NUCLEAR REGULATORY COMMISSION

Title: Advisory Committee on Reactor Safeguards Reliability and Probabilistic Risk Assessment Subcommittee

Date: Thursday, December 14, 2006

ESBWR Risk Management Overview

Figure 5.1-3. Isolation Condenser System Schematic

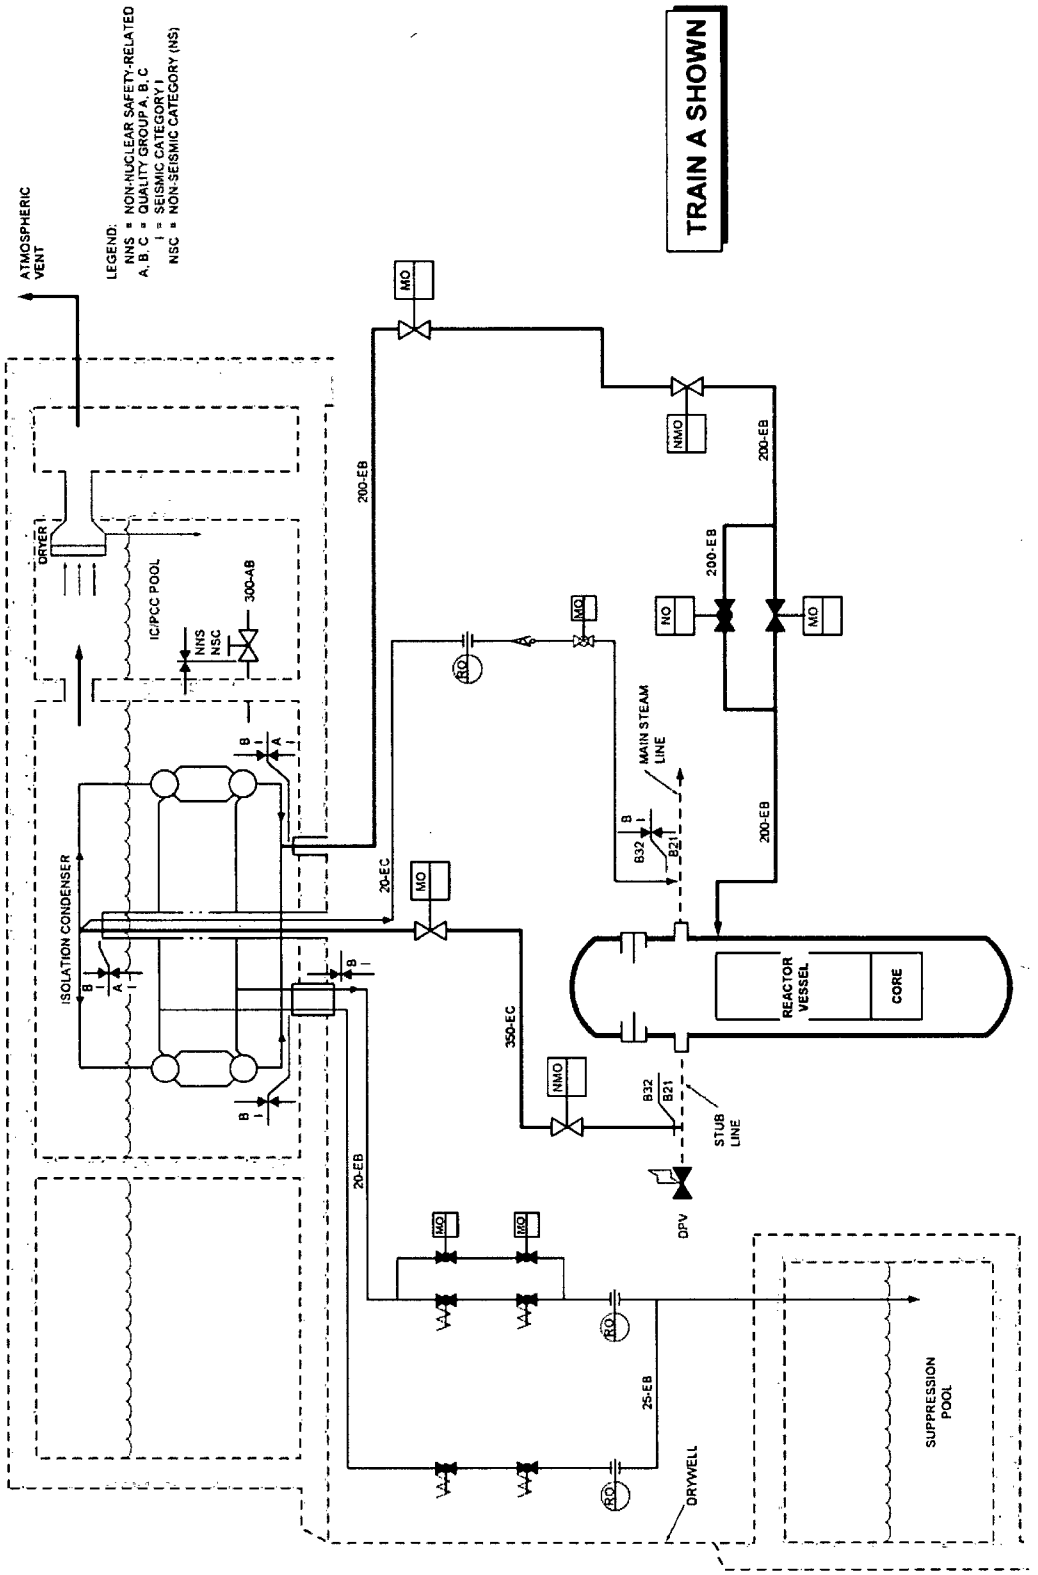
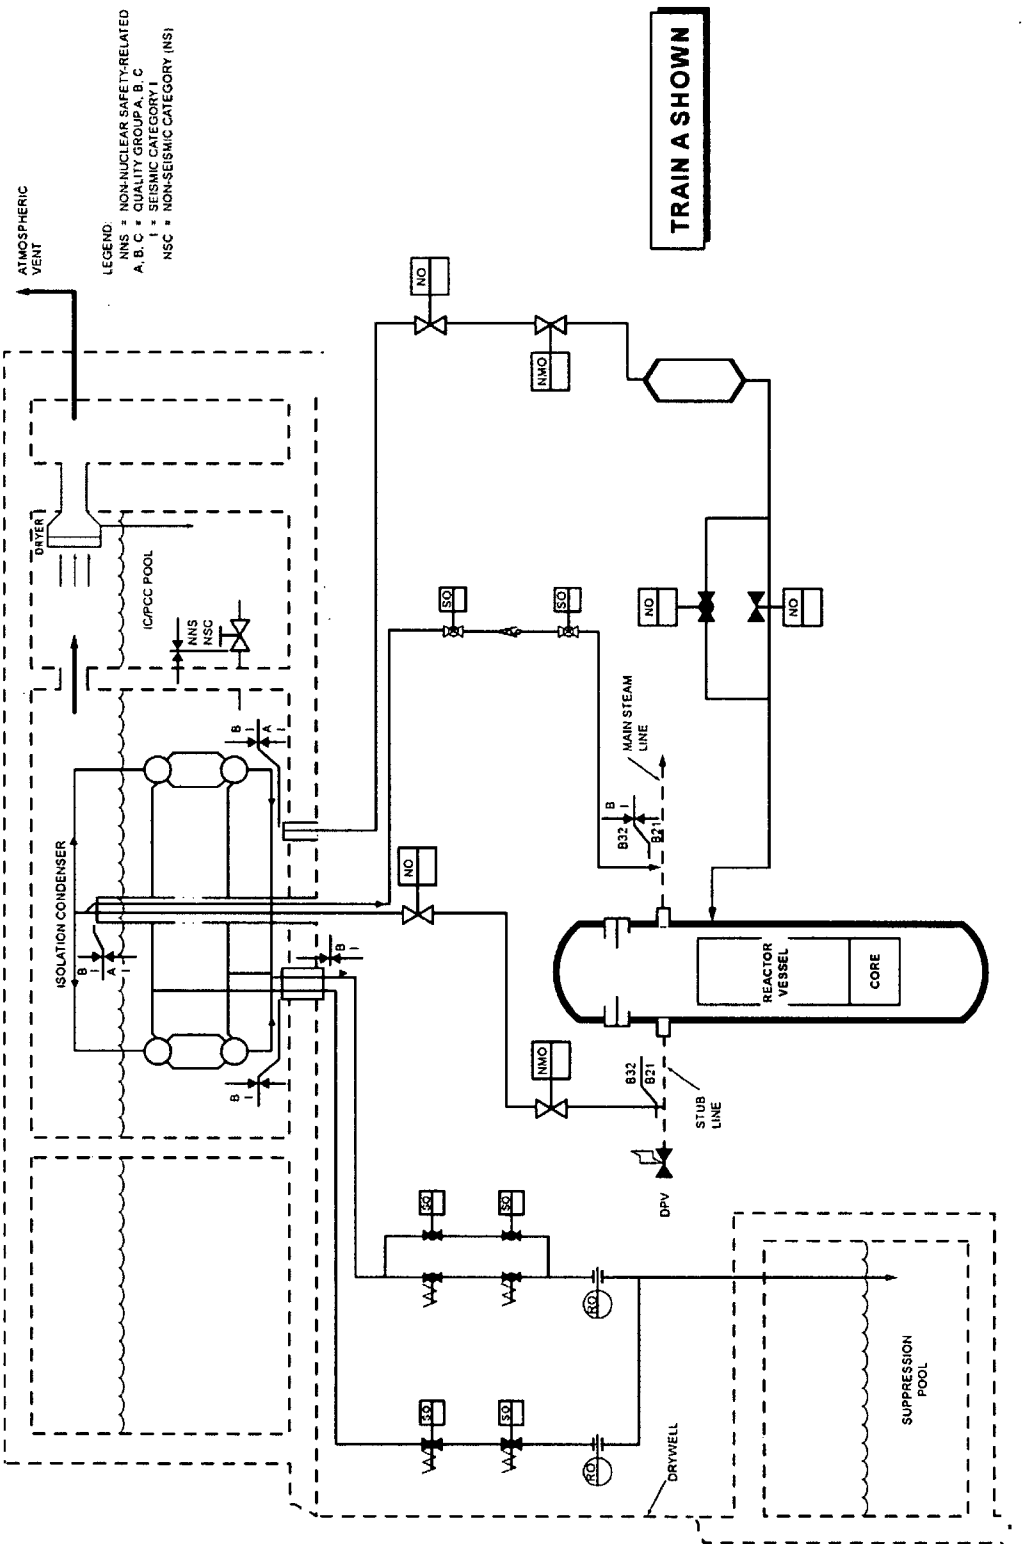
1 the way that this is set up here, but we lose the
2 isolation condenser system from something as simple as
3 not starting two CRD pumps. So the plant has been
4 reconfigured so that this sequence in the middle here
5 goes away and now it looks more like the loss of off-
6 site power at the generic transient.
7 CHAIRMAN APOSTOLAKIS: Yes. Now --
8 MR. WACHOWIAK: We'll have to look into
9 that operation actually.
10 CHAIRMAN APOSTOLAKIS: Yes.
11 MR. WACHOWIAK: I know we --
12 CHAIRMAN APOSTOLAKIS: That's why I
13 wondered.
14 MR. WACHOWIAK: Because when the
15 dependence analysis based on all the cutsets and I
16 just don't remember how that one came out off the top
17 of my head.
18 CHAIRMAN APOSTOLAKIS: Well, remember
19 cutsets that are here are simply the product.
20 MR. WACHOWIAK: Yes.
21 CHAIRMAN APOSTOLAKIS: Yes. The
22 individual sequences, you know, if you look at these
23 three or the --
24 MR. WACHOWIAK: Yes.

ICS P&ID	Figure 5.1-3 Rev 1
	Figure 5.1-3 Rev 2
LOFW Water Level	Figure 15.2-16c Rev 1
	Figure 15.2-16c Rev 2
TGEN Event Tree	Figure A.3-1 Rev 1
TFDW Event Tree	Figure A.3-3 Rev 1

Figure 15.2-16c. Loss of All Feedwater Flow

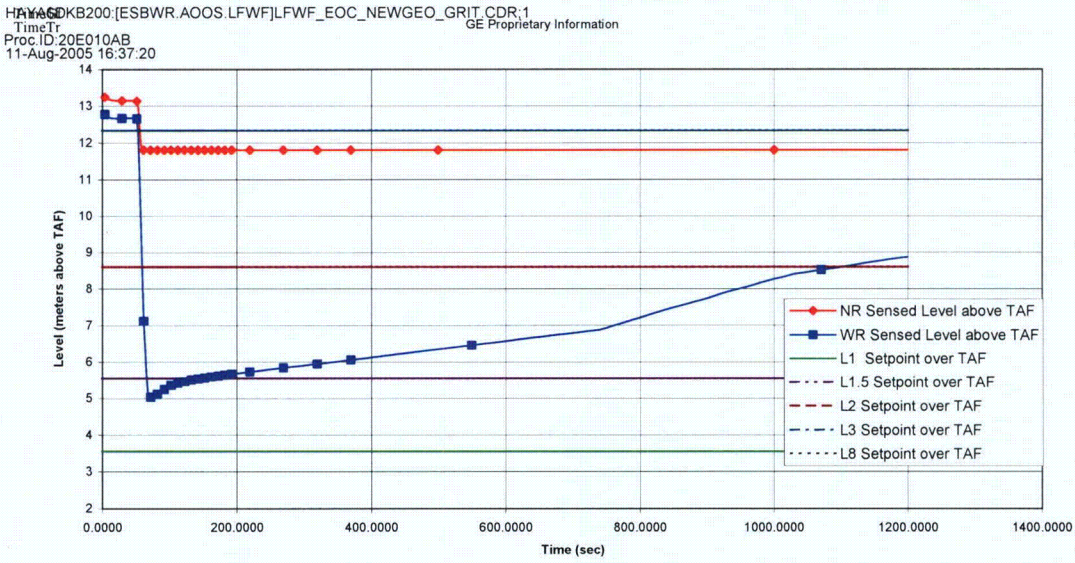
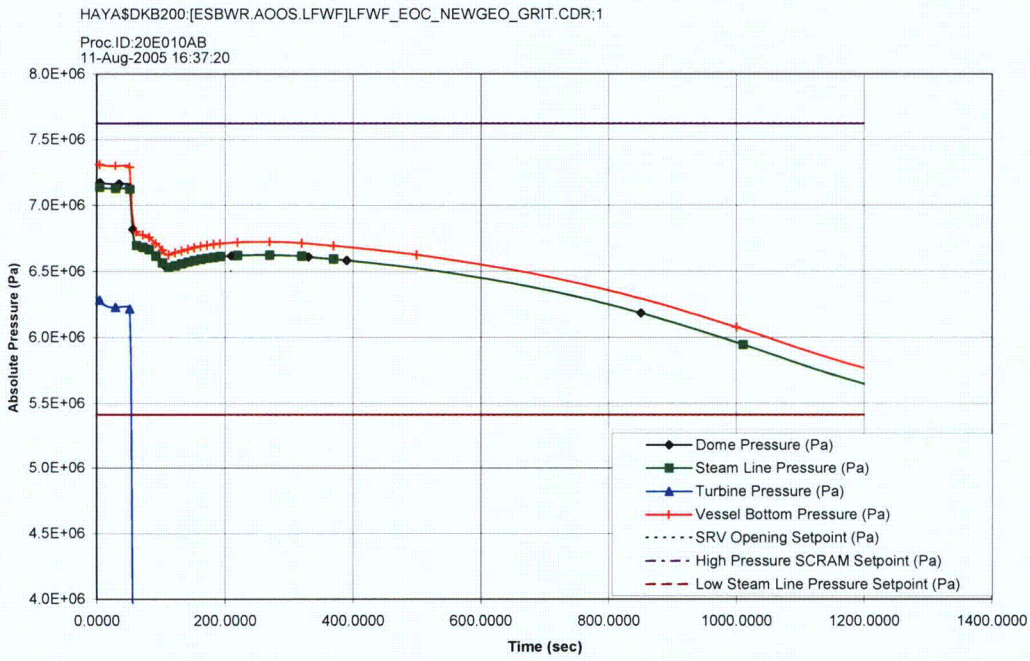
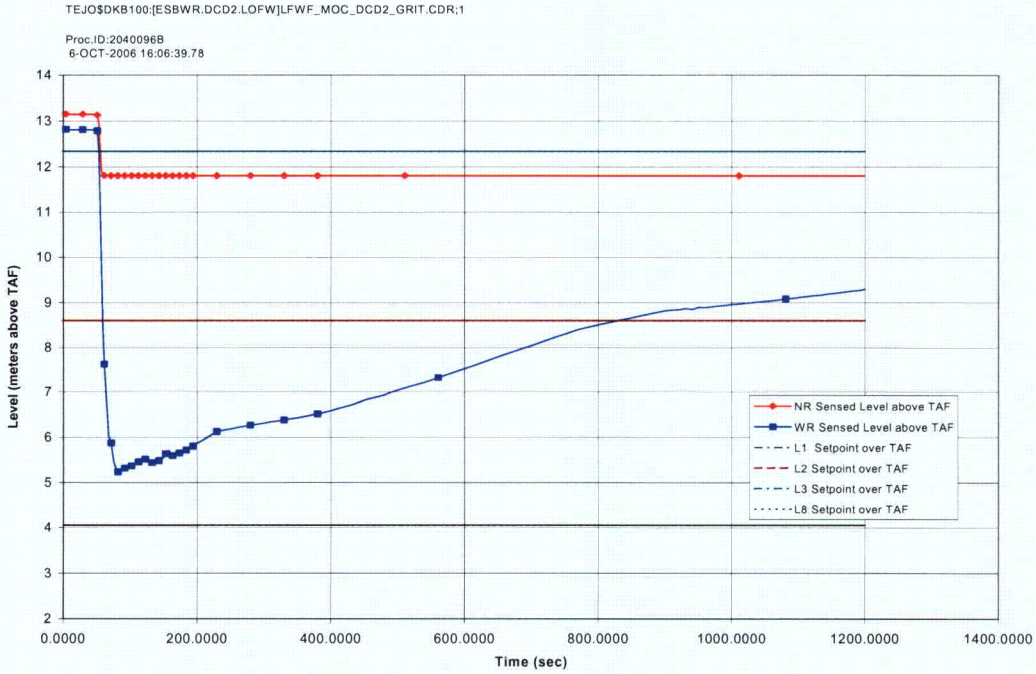
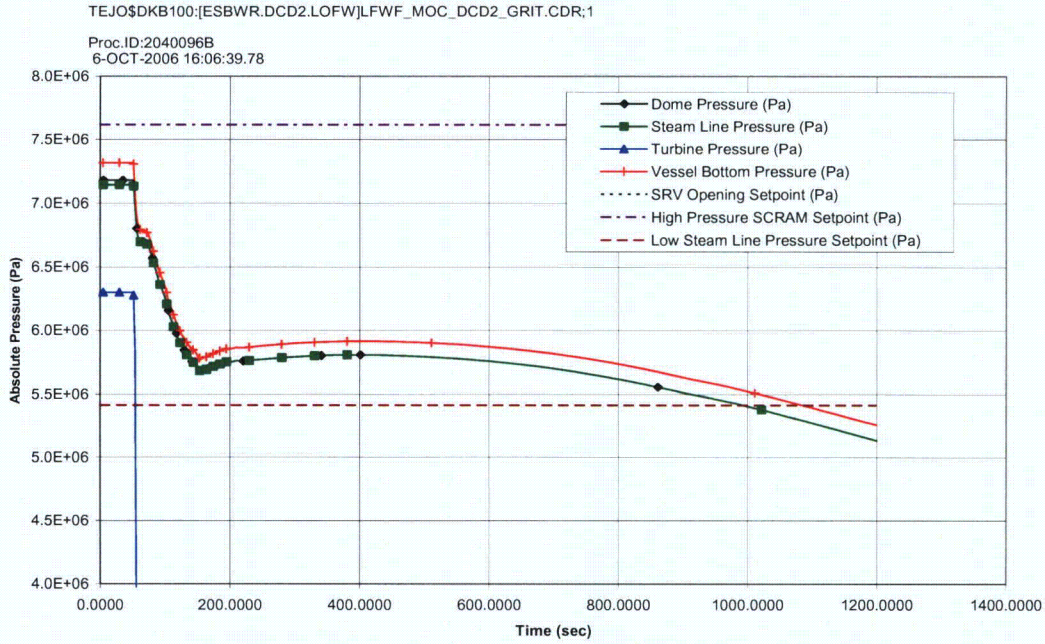
1 power then, but it illustrates the issue. The water
2 level in this scenario initially drops below Level 1.5
3 and the timer starts and in order to get water back up
4 above this Level 1.5 in time to get rid of the -- to
5 clear the signal, we have to have two CRD pumps.
6 It looks here like the slope will allow
7 only one CRD pump to operate and be able to clear that
8 in the time frame that we have, but we know in those
9 cases, and the dynamics of the early part of the
10 scenarios, just won't allow it.
11 MEMBER WALLIS: Can I ask a question since
12 we're now here?
13 MR. WACHOWIAK: Okay.
14 MEMBER WALLIS: I read about the feedwater
15 and CRD injection. It talks about one SBW pump and
16 one common pump and so on. And then it said that if
17 SBW fails to keep the level above Level 2 CRD
18 injection initiates, this is described in the PRA,
19 right?
20 MR. WACHOWIAK: Yes.
21 MEMBER WALLIS: But does the PRA run a

MR. WACHOWIAK: So what we need to do or what we needed to do was fix this. Now, the reason why we went there in the plant has more to do with investment protection than it does with core damage prevention. With the core damage frequency, you know, the way we estimated that sequence at, approximately, $2x10^{-8}$, you probably -- we probably could have lived with it in the PRA space.

However, on the plant side, using the depressurization system when it's really not -- when it's best not to use it is something to be avoided. And what we would like to do and we are working toward doing is providing protections in the plant to ensure that an unnecessary depressurization won't happen in the life of the plant.

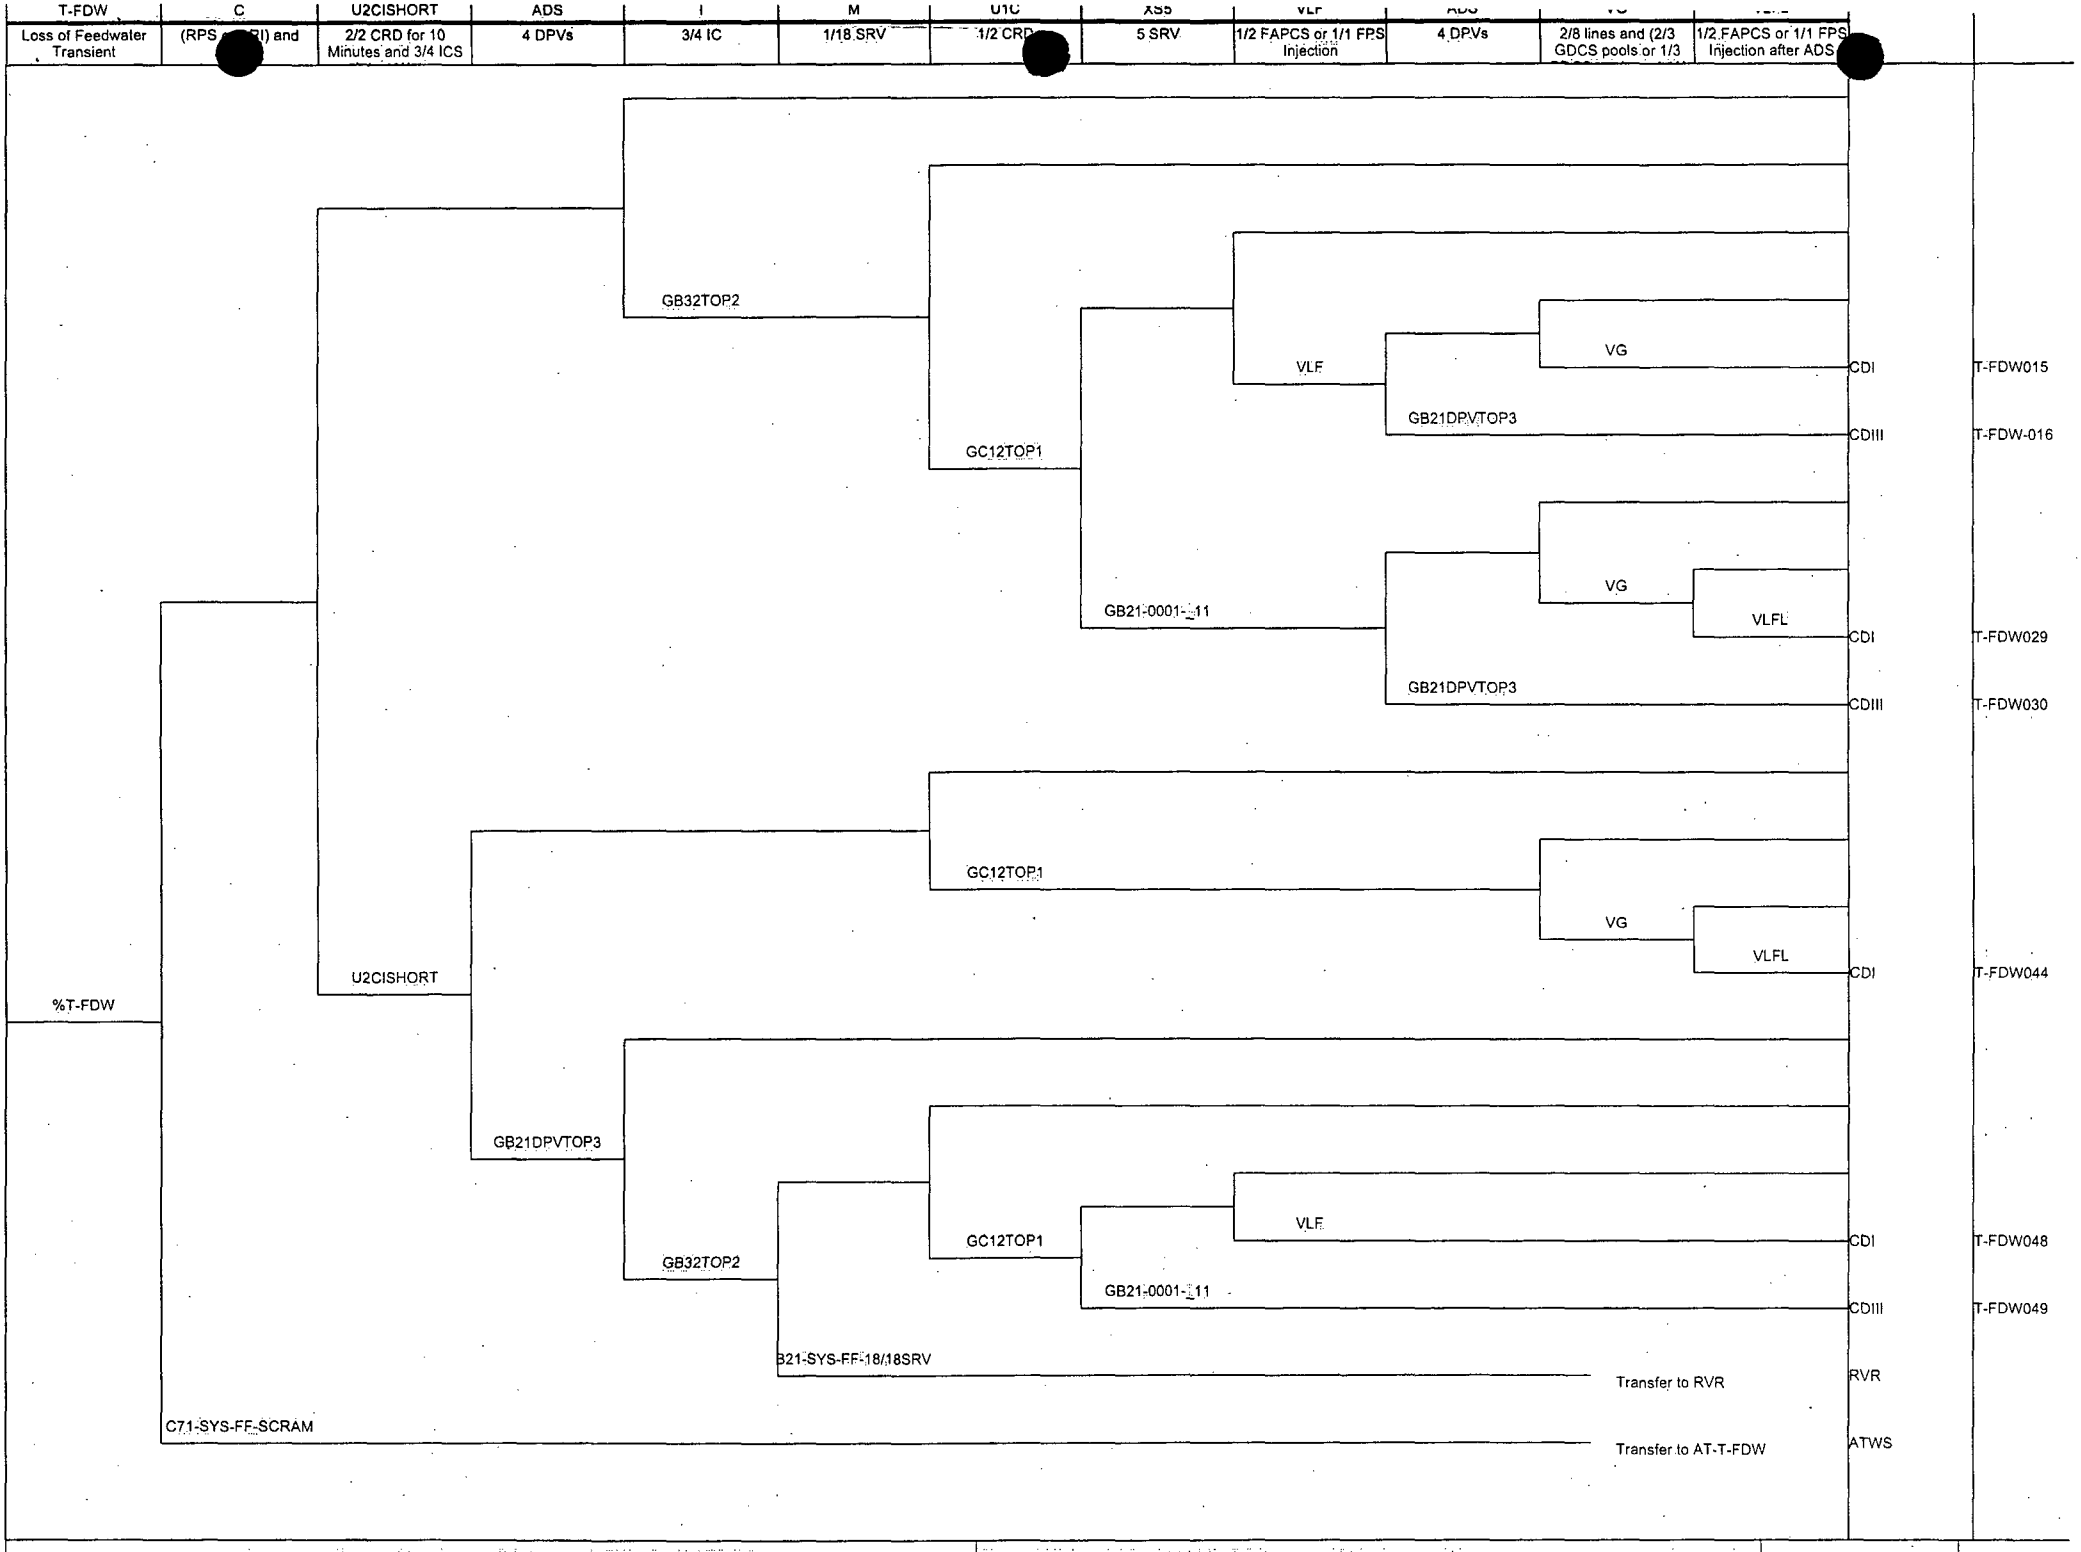
1 200 concepts, in almost all of the sequences, you have
2 two events mispositioning your valve at F013A and
3 mispositioning for F013B. So and then you multiply
4 the numbers that you show. I mean, these I guess are
5 the cutsets availability. So what you are saying is
6 that both must fail, right? But tell me if you need
7 any more.
8 MR. WACHOWIAK: That's correct. We're all
9 here and it looks like this loss of feedwater path,
10 which was --
11 CHAIRMAN APOSTOLAKIS: Well, I'm looking
12 at the table. Where are you now?
13 MR. WACHOWIAK: Like that is your picture
14 there for the loss of feedwater?
15 CHAIRMAN APOSTOLAKIS: Yes.
16 MR. WACHOWIAK: Which is exactly the same
17 structure as loss of off-site power.
18 CHAIRMAN APOSTOLAKIS: Okay.
19 MR. WACHOWIAK: I have cut off -- in this
20 picture up here, I have cut off the second half of --
21 CHAIRMAN APOSTOLAKIS: Right.
22 MR. WACHOWIAK: -- the tree. So we can

22 MR. WACHOWIAK: -- turns out to be the
23 dominant failure mode for the CRD.
24 CHAIRMAN APOSTOLAKIS: CRD, yes, okay.
25 MR. WACHOWIAK: So the question, one

1 question could be like what when we did the standby
2 liquid controls. Should these valves be instrumented
3 in the alarm, so that that can happen? The answer is
4 probably yes. Are we required to do it for the 10^{-8}
5 sequence? No. And so at this point, we haven't gone
6 back and said you have to do that. We have said we
7 would like you to consider whether or not you would do
8 that.
9 CHAIRMAN APOSTOLAKIS: Yes.
10 MR. WACHOWIAK: It's a human-man-machine
11 interface being the things they are looking at.
12 CHAIRMAN APOSTOLAKIS: I guess you are
13 partial to the issue of acceptable risk. I mean,
14 there is always a sequence that we don't need, that we
15 don't want to push.
16 MR. WACHOWIAK: Right.
17 MEMBER SIEBER: I don't have a quarrel
18 with that.
19 CHAIRMAN APOSTOLAKIS: But at the same
20 time, there are certain rules when you do PRA with
21 dependence and all that and it would be nice to follow
